MONTGOMERY COUNTY HISTORIC PRESERVATION COMMISSION
STAFF REPORT

Address:	15 Columbia Ave., Takoma Park	Meeting Date:	10/26/2022
Resource:	Non-Contributing Resource Takoma Park Historic District	Report Date:	10/19/2022
Applicant:	Jeff Dorn Wakako Tokunaga, Architect	Public Notice:	10/12/2022
Review:	HAWP	Tax Credit:	n/a
Case No.:	952481 REVISION	Staff:	Dan Bruechert
Proposal:	Building Alterations, Rear Addition, and Hardscape Alteration

15 COLUMBIA AVE
ADDITION/RENOVATION

1 LOWER LEVEL PLAN
A100 1/4" = 1'-0"

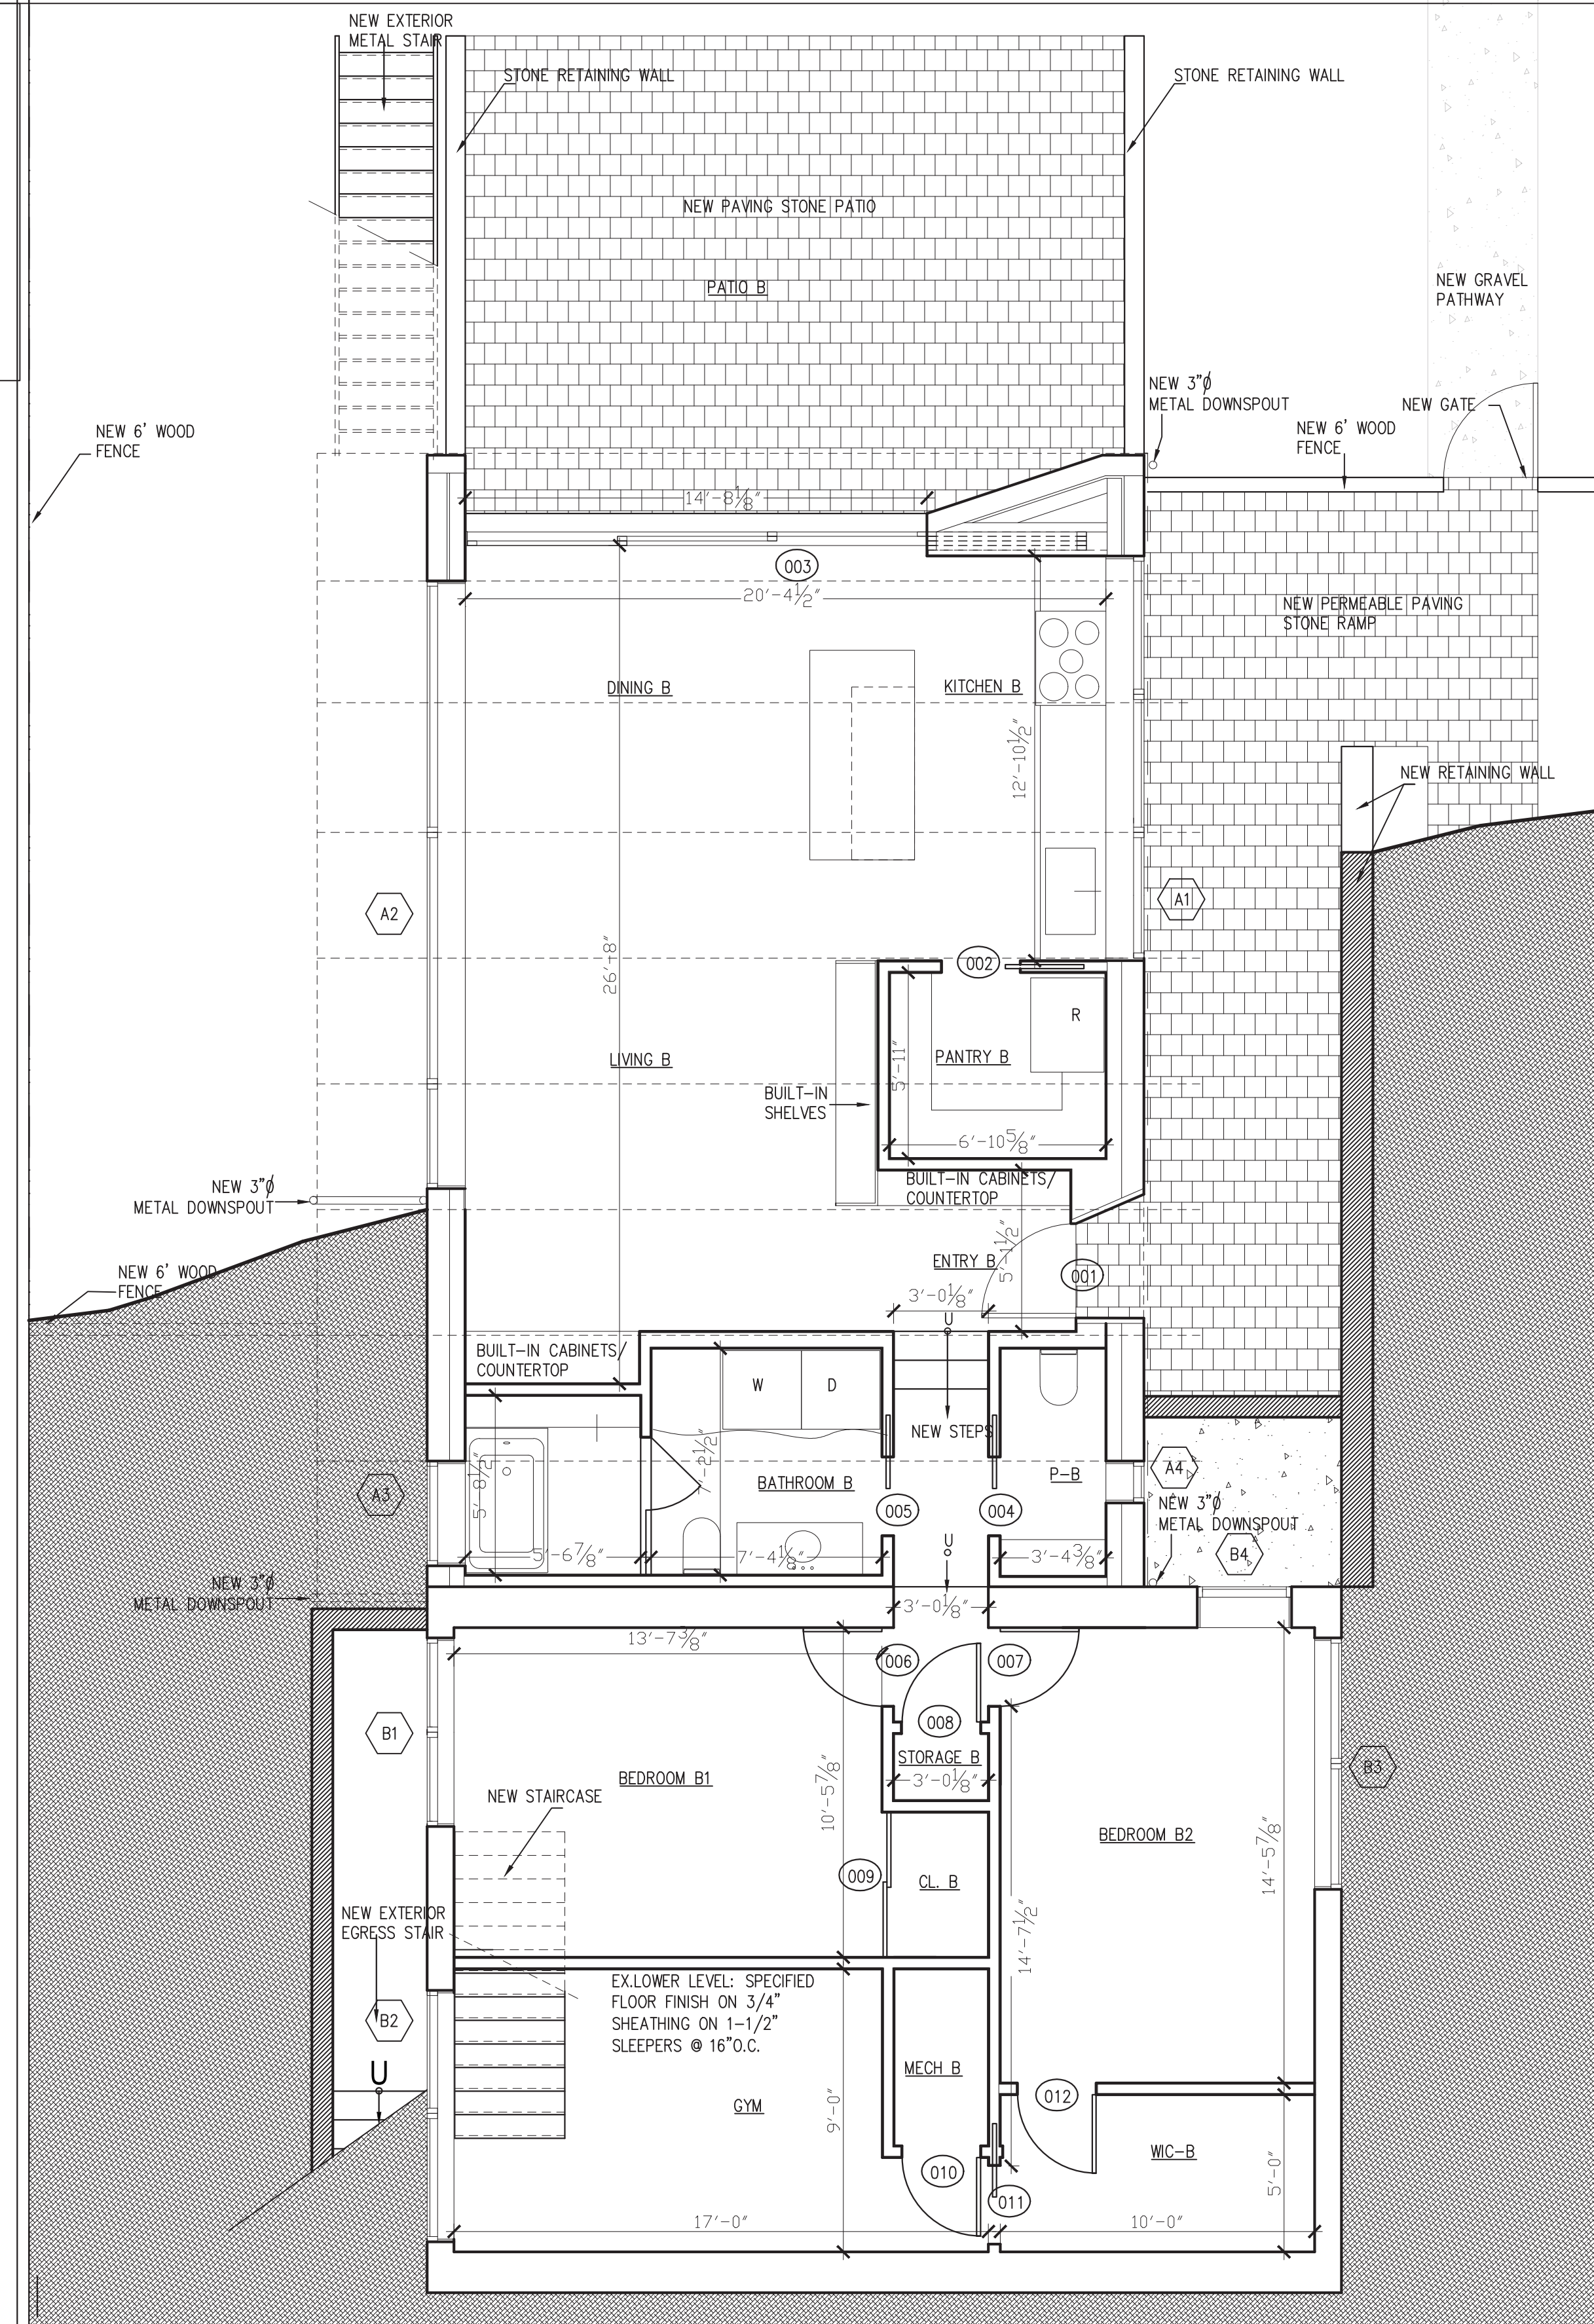
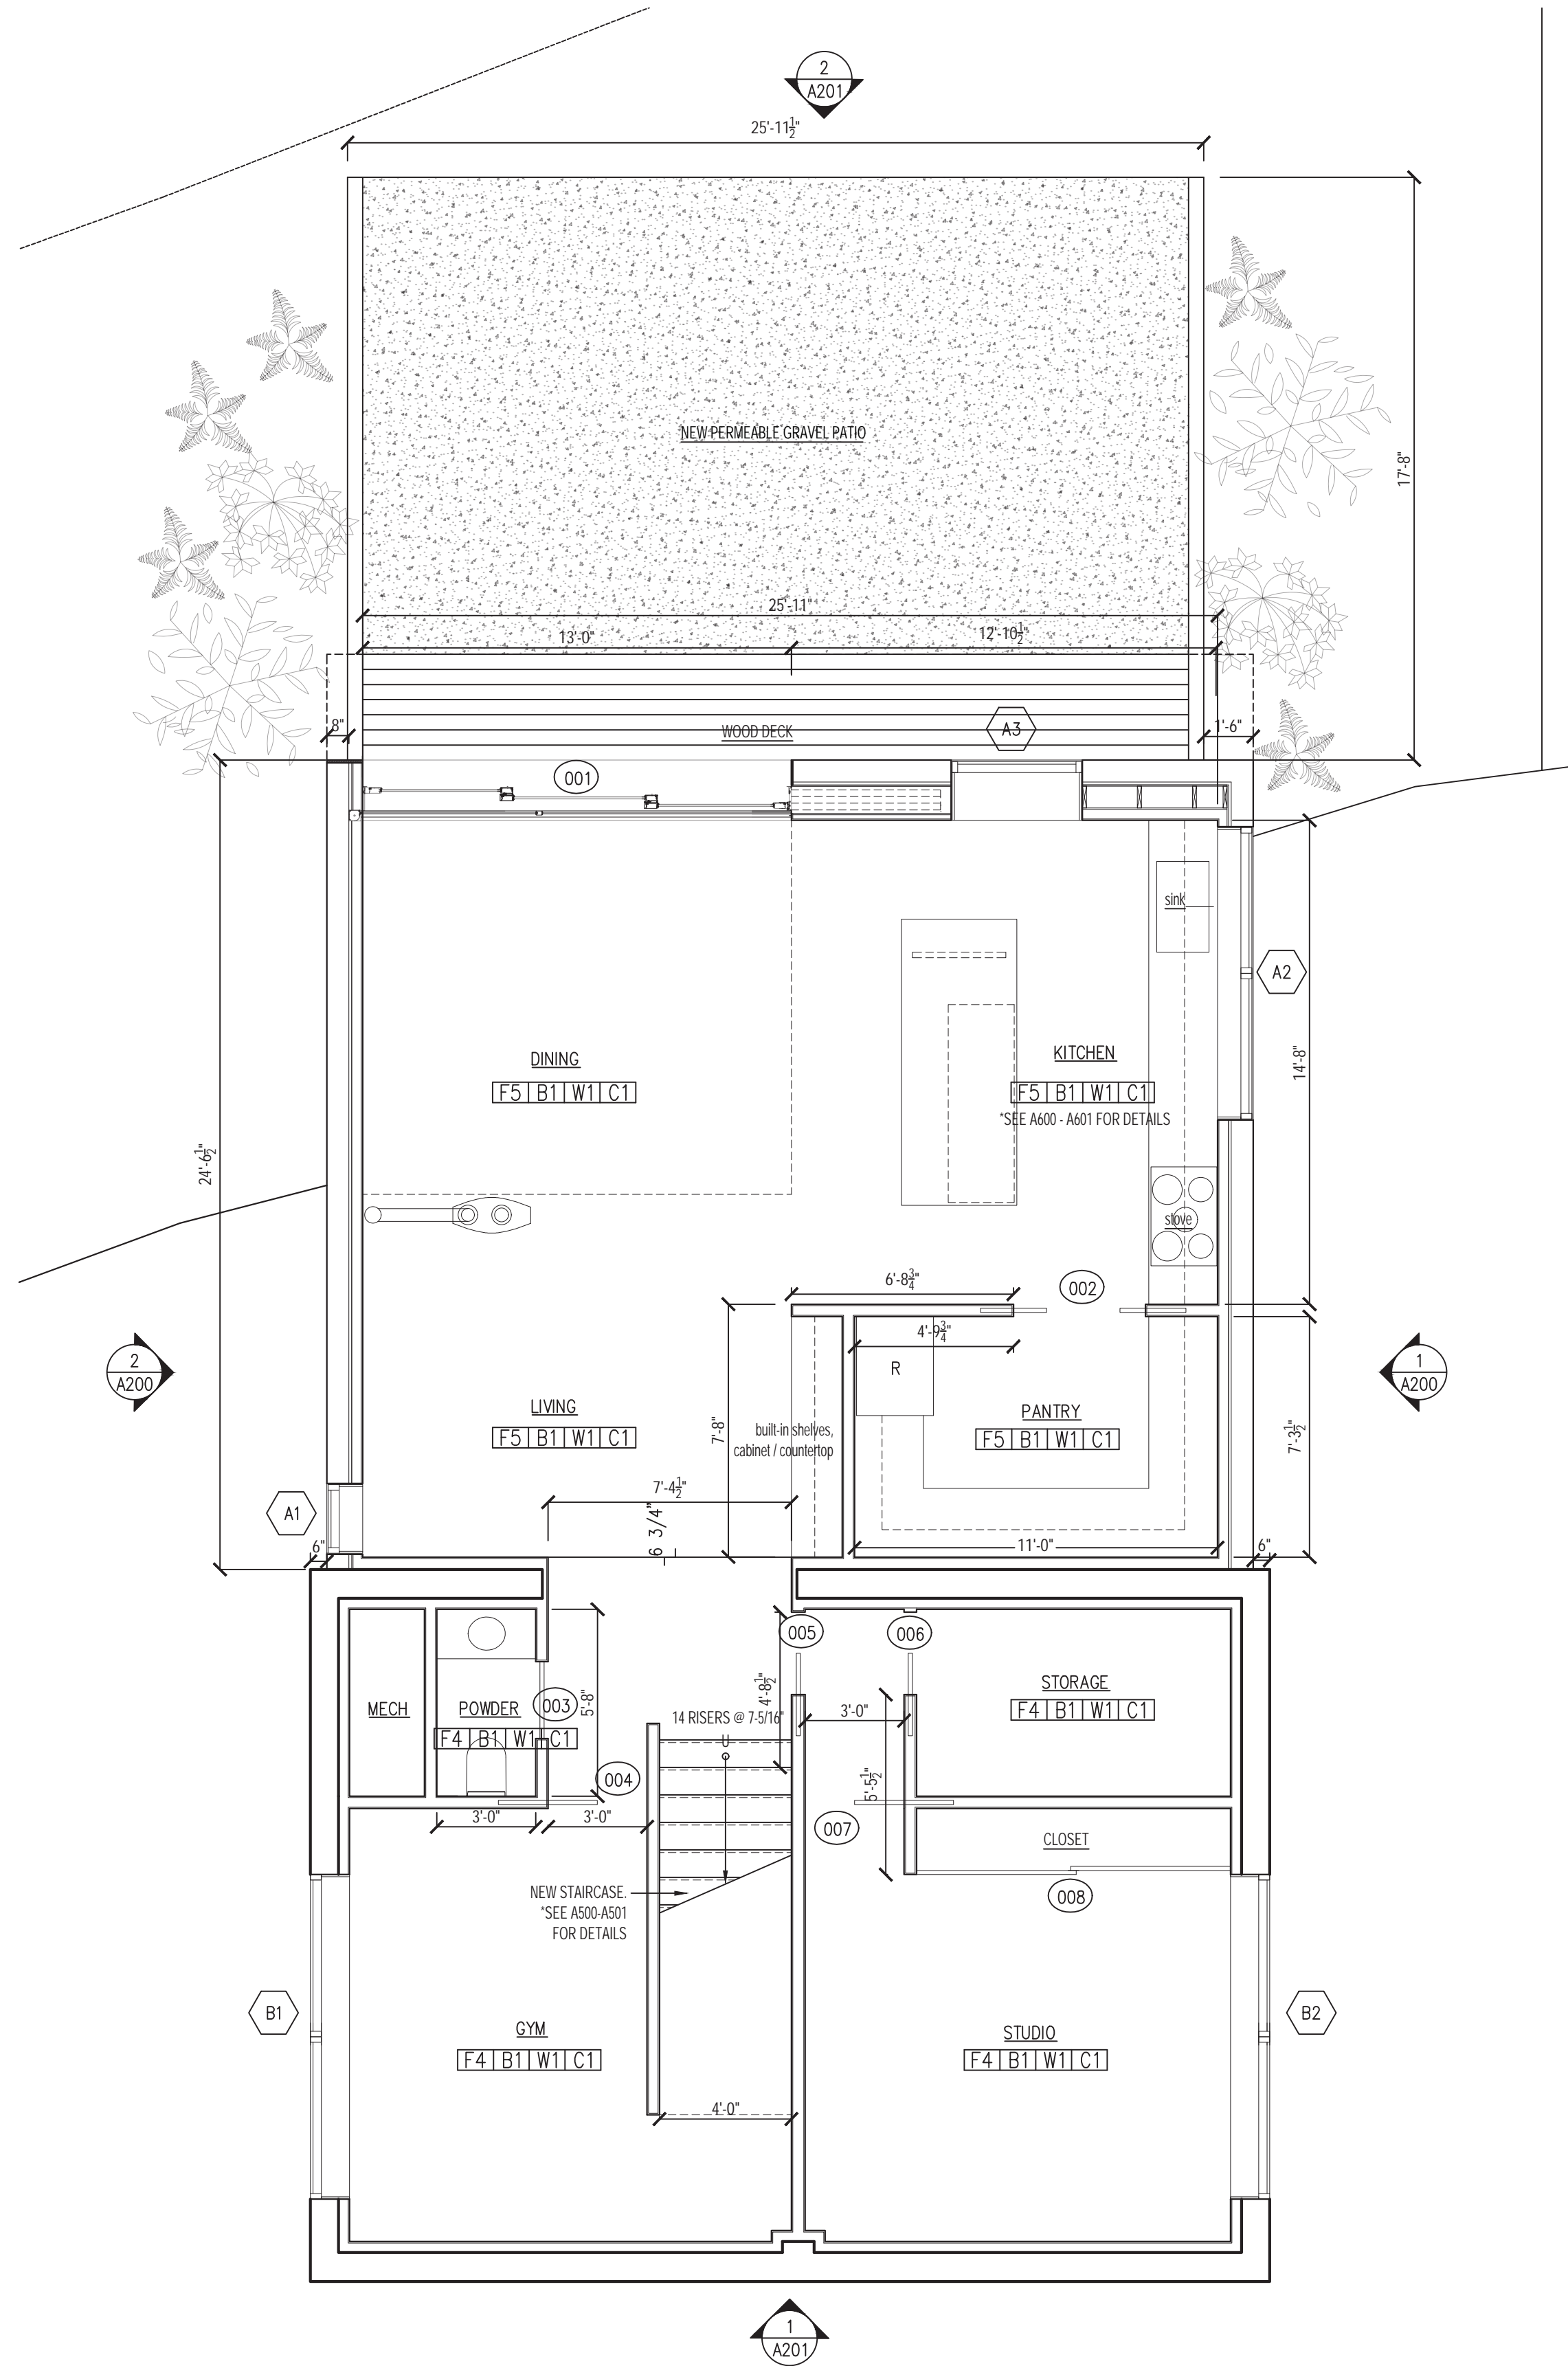
Materials for the addition include a parged CMU block foundation, vertical siding to match the second floor of the existing house, aluminum-clad windows, and an asphalt shingle roof. The applicant has removed the slat wall and rear porch from the design. The size and location of the windows on the rear addition have been changed from the approved design, however, the addition's inset makes the left side elevation less visible from the right-of-way.

Staff finds the proposed addition is a reduction in scale that will be less visible from the right-of-way. Staff does not find that the addition will impact the size and massing of the resource to the point that it degrades the character of the surrounding streetscape and recommends the HPC approve the revised design.

1 WEST ELEVATION
A200 1/4" = 1'-0"

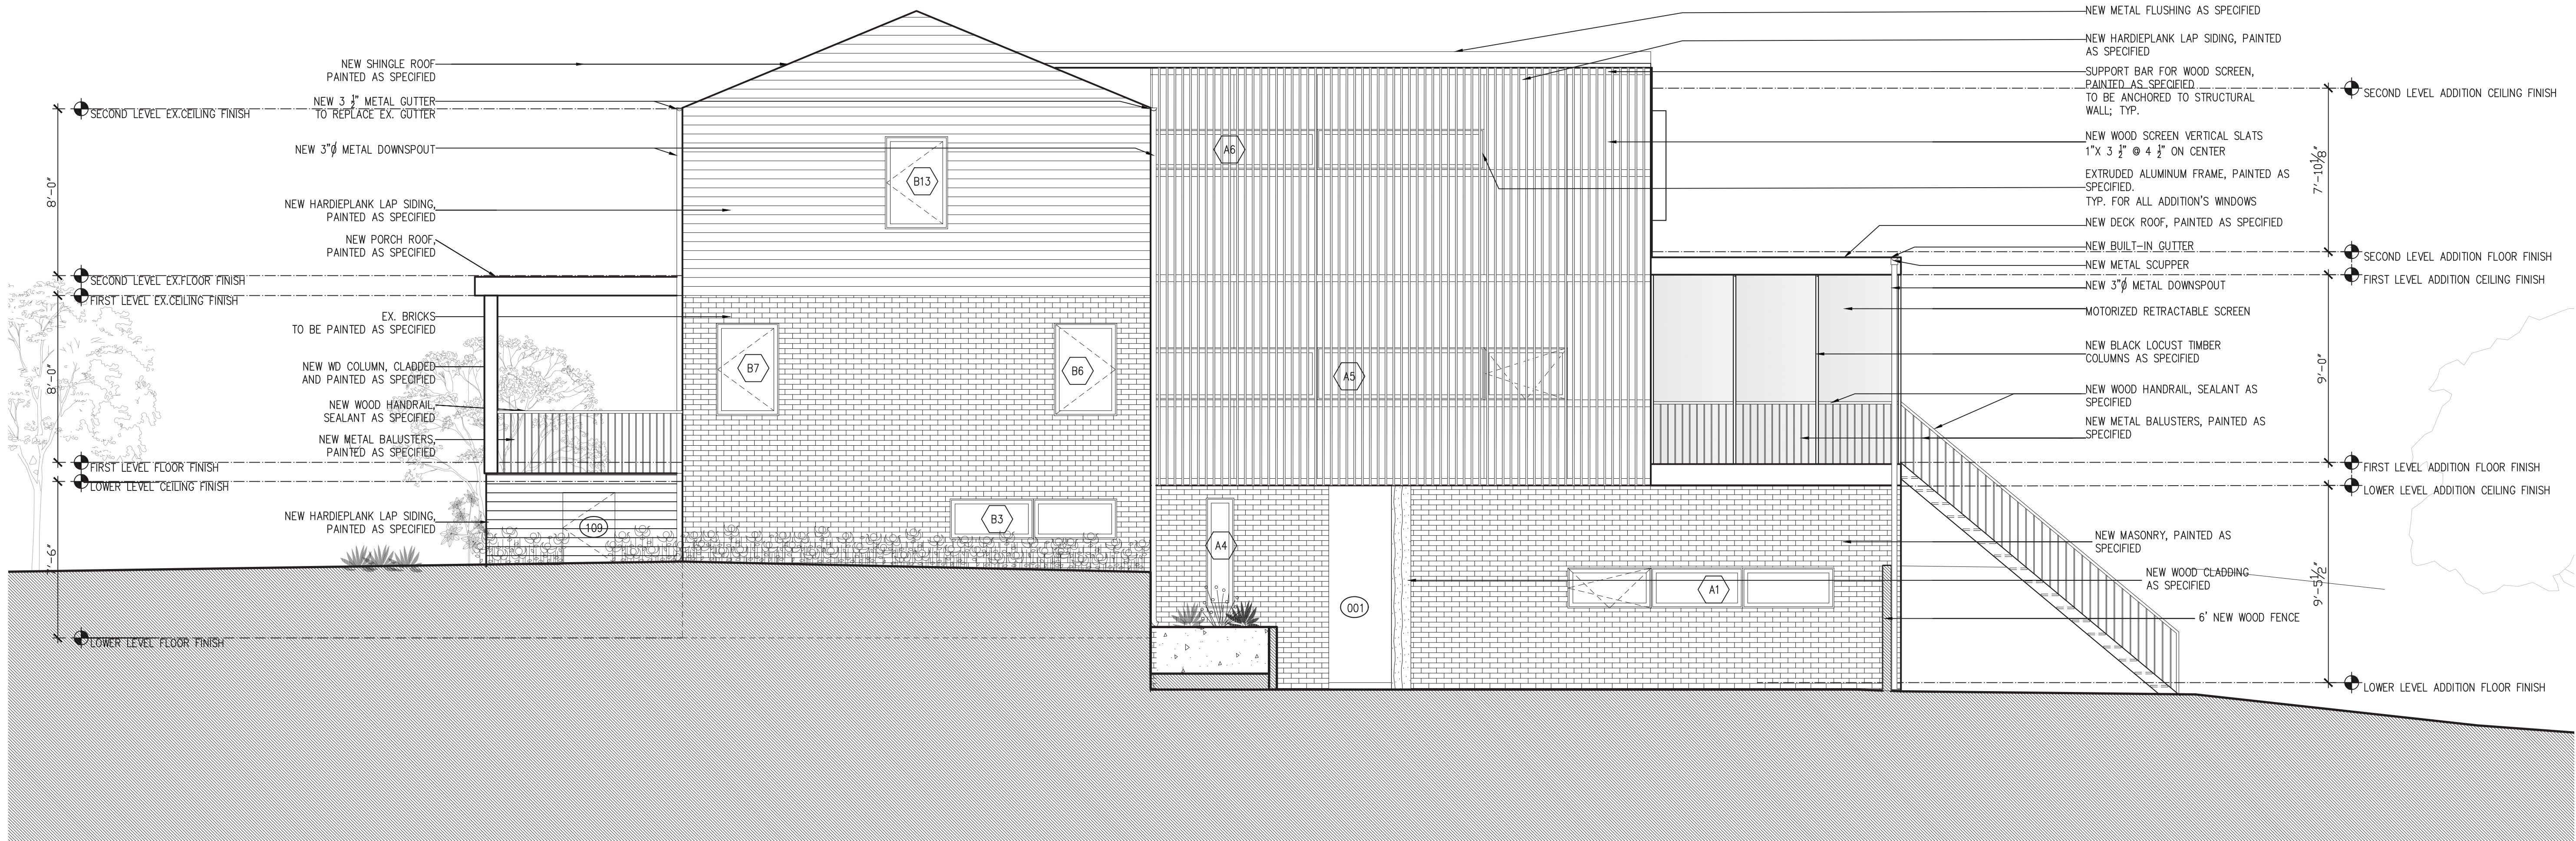
The next change proposed to the approved design is new siding; the approved siding was a fiber cement lap siding. Now, the applicant proposes to install a vertically oriented siding that will extend to the rear addition (discussed below).

The approved HAWP was for a full-length front porch with a flat roof and metal railing. The revised design maintains the same general design, but only covers approximately 3/4ths of the front elevation. Additionally, the railing has been changed from a metal design to horizontal wood.
